Docket Nos. 50-237 and 50-249

Change No. 22
License No. DPR-19
Change No. 13
License No. DPR-25

Pursuant to Section 50.59 of 10 CFR Part 50, the Technical Specifications of Facility Operating Licenses Nos. DPR-19 and DPR-25 are hereby changed by replacing pages 69, 70, 138, 142, 142B, and 158-185 with the revised pages appended hereto.

Figure 3.4.1 Standby Liquid Control Solution Requirements

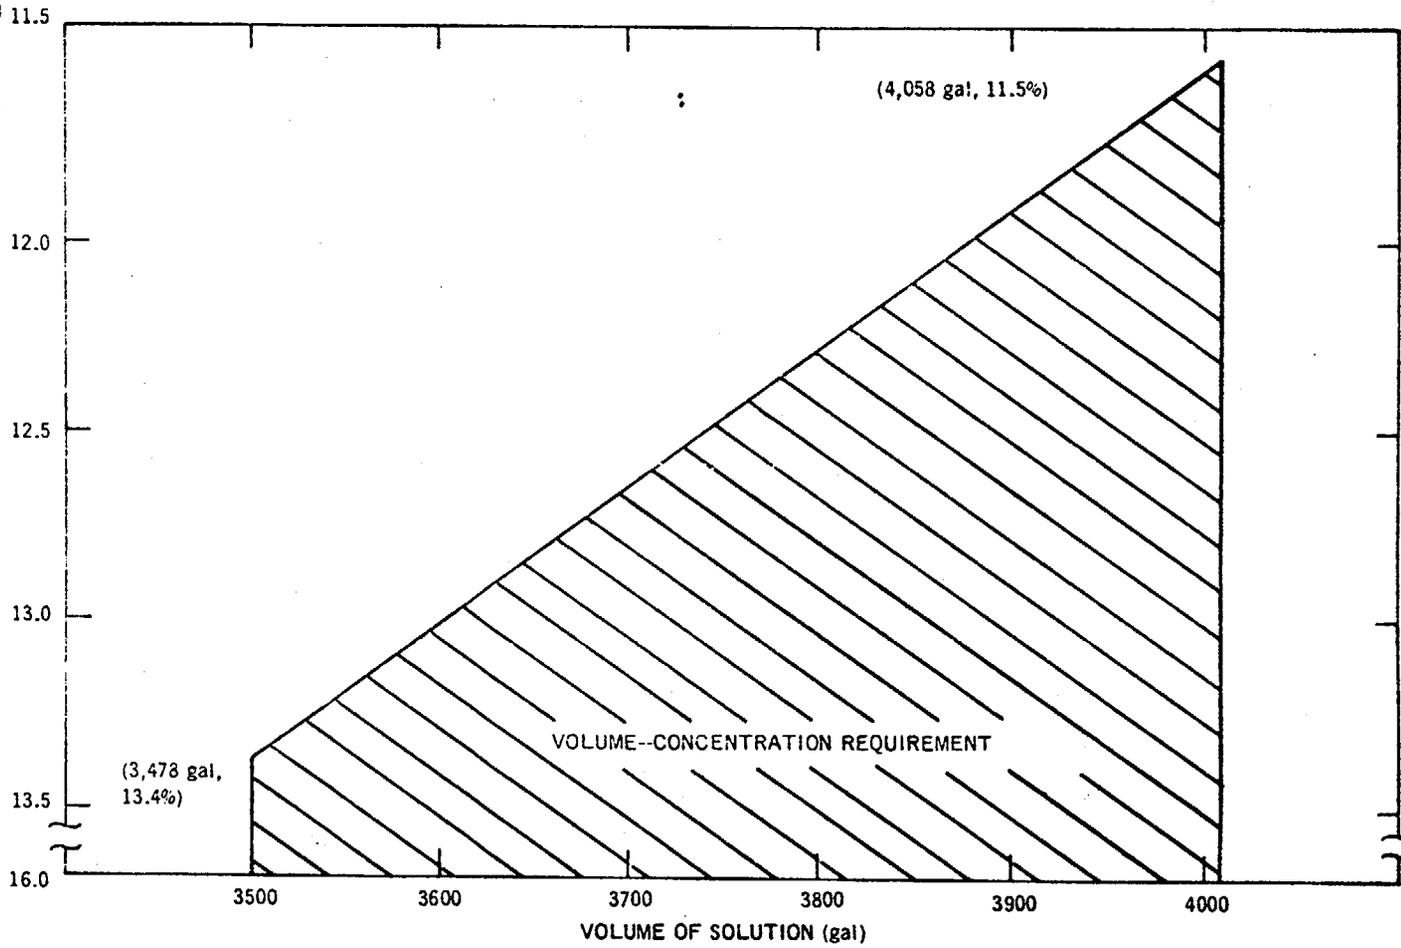
The change concerning liquid poison corrects a typographical error.

FIGURE 6.1.1

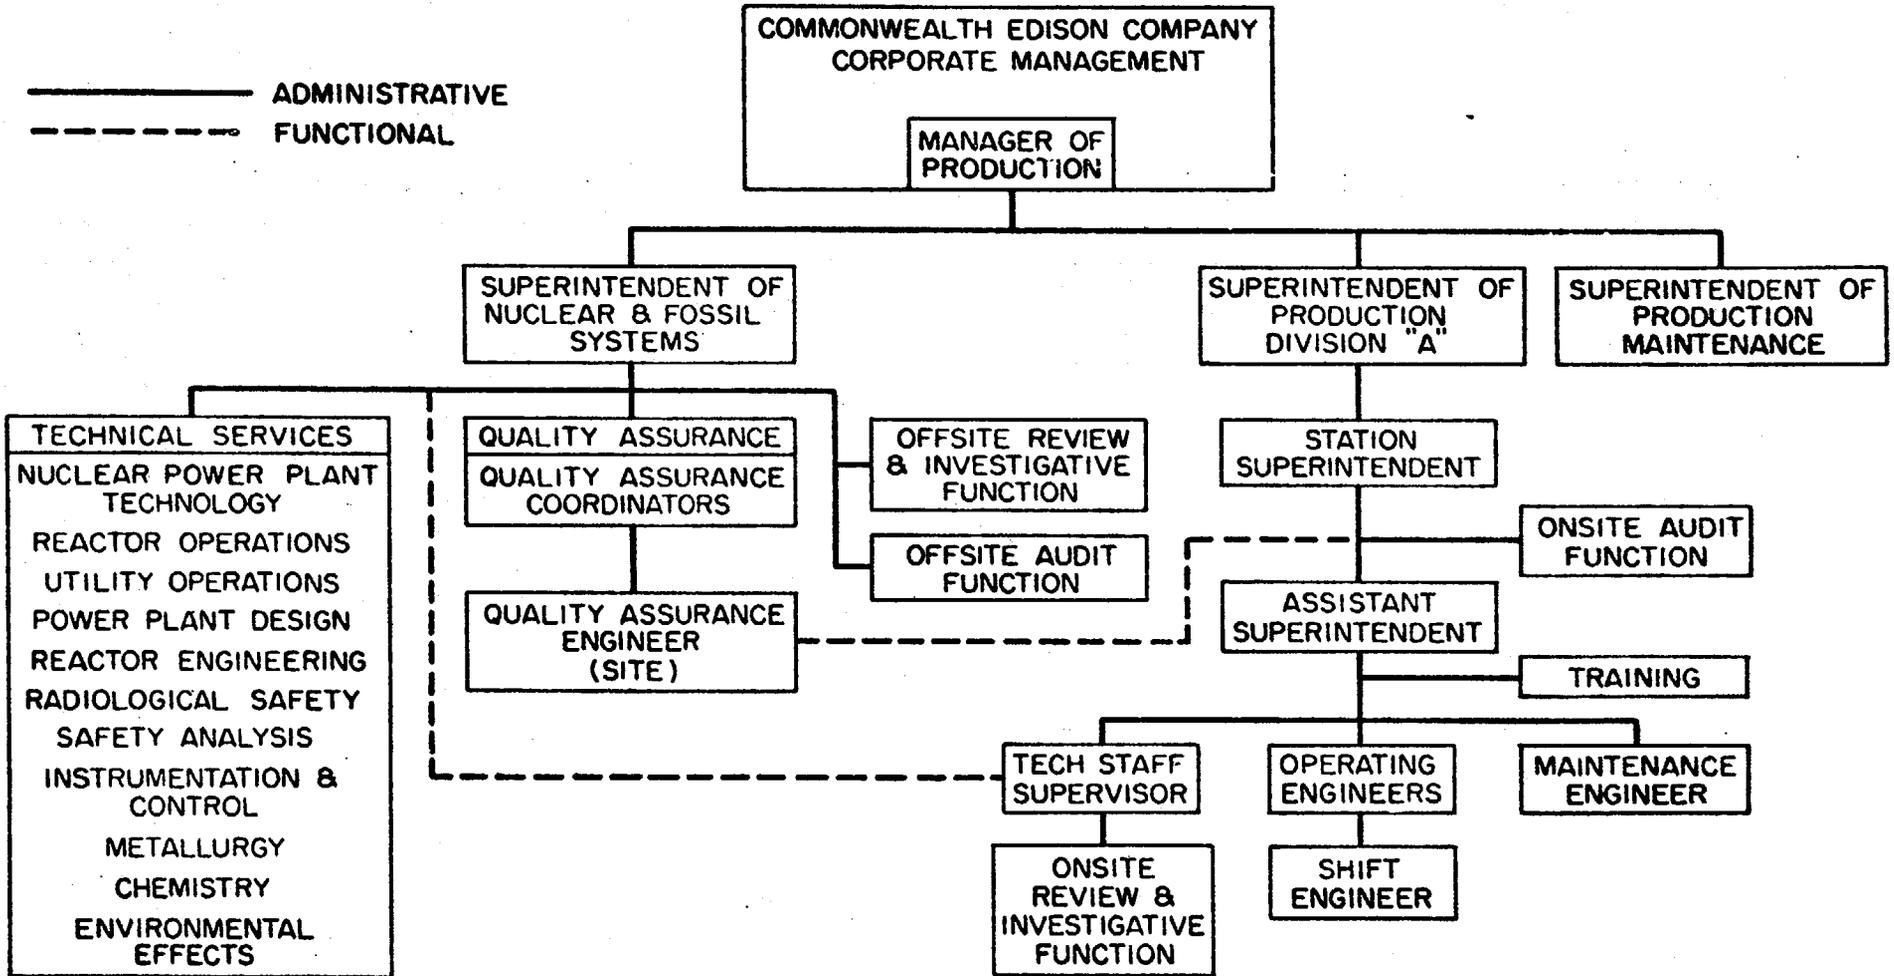
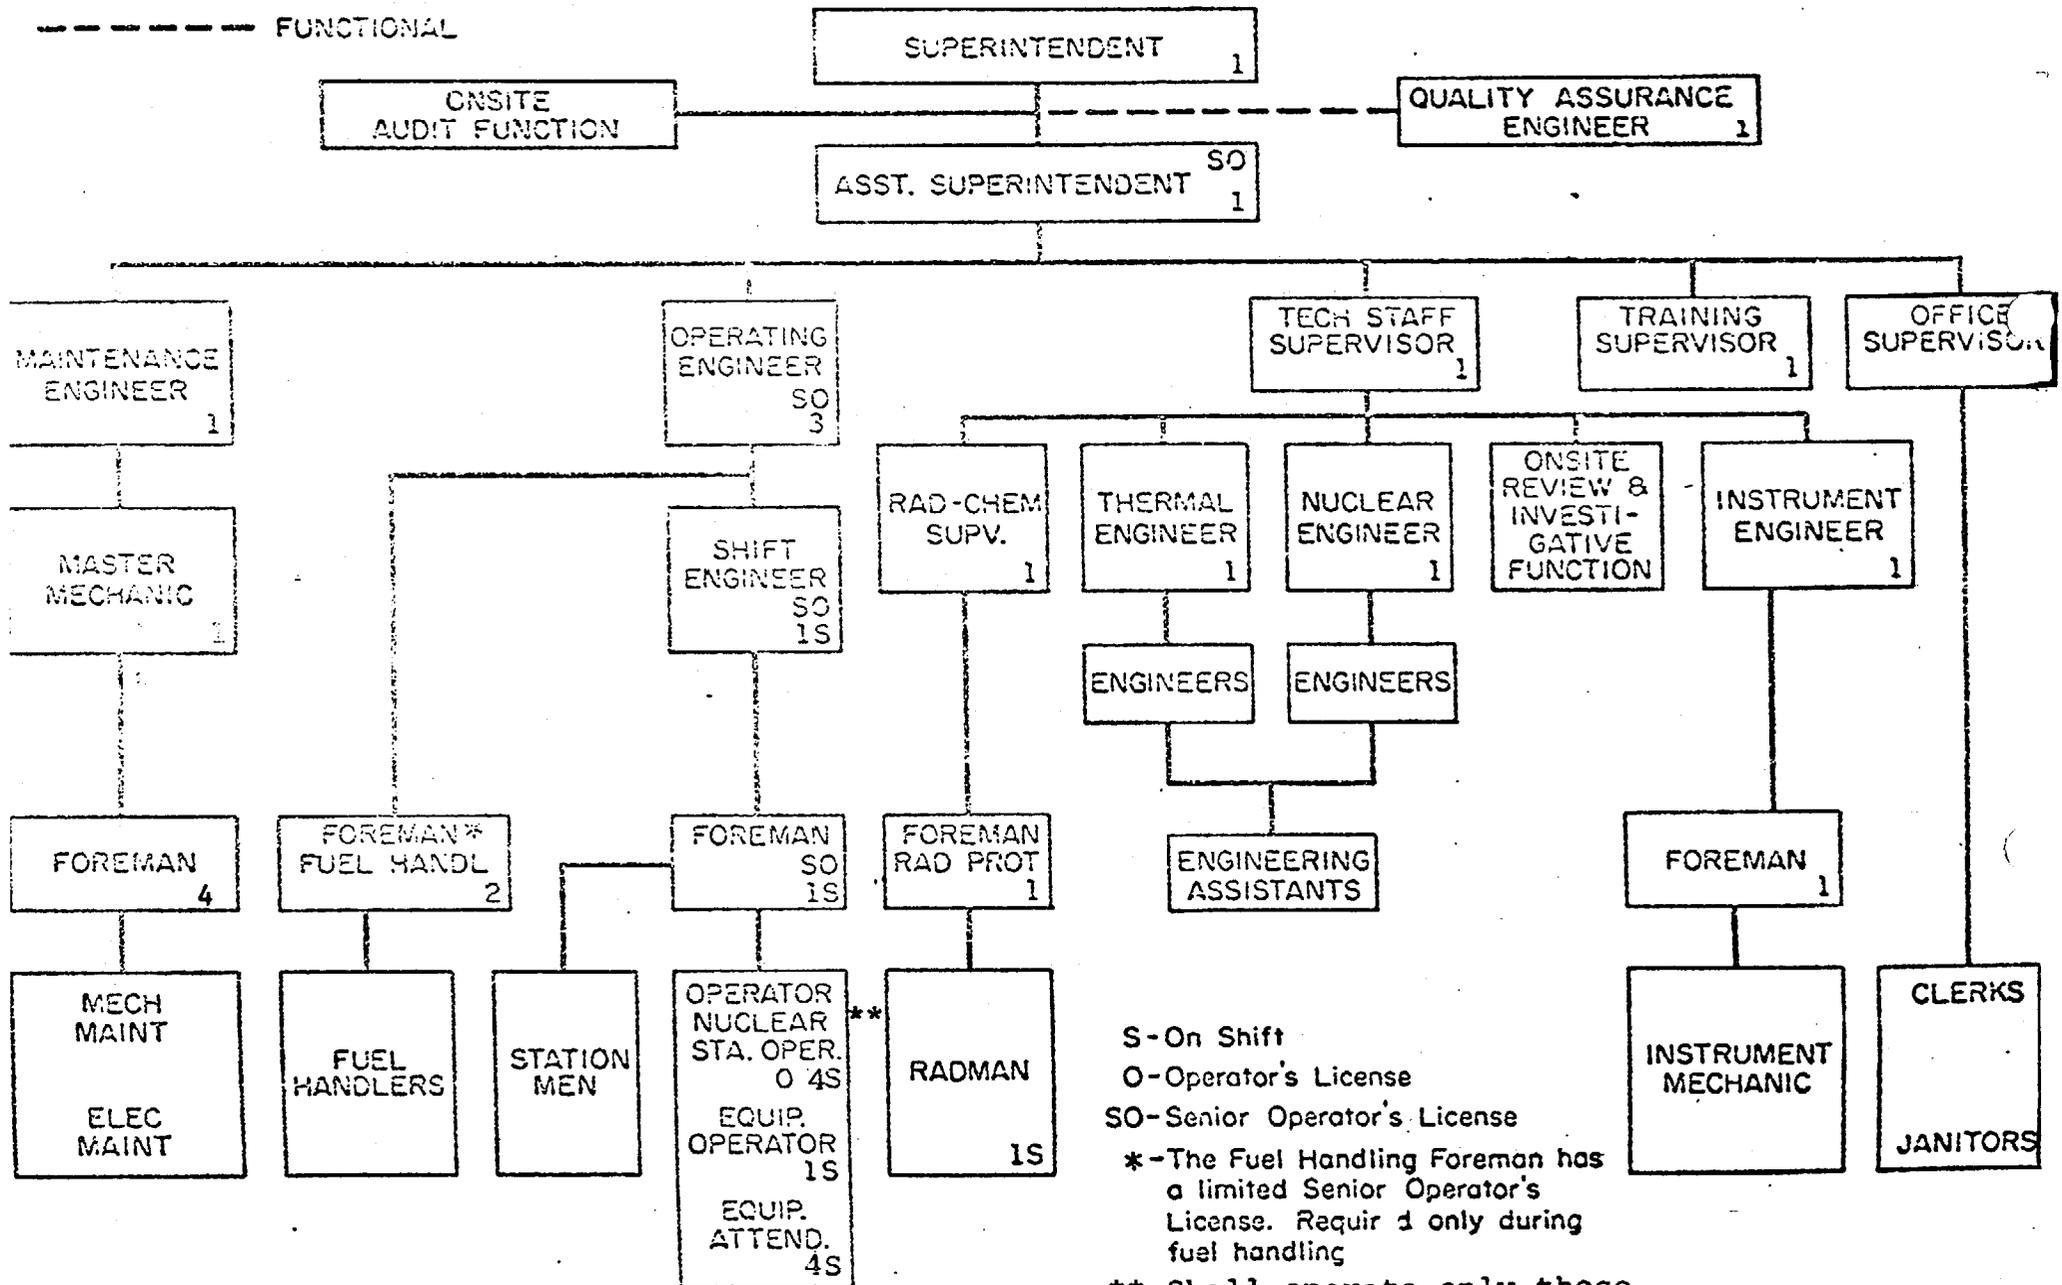
The proposed administrative control specifications are based on those approved for Quad-Cities in May 1973. During review of these changes, we informed your staff that modifications were necessary to continue present requirements for special reports and to require a larger minimum staff. These modifications have been made.
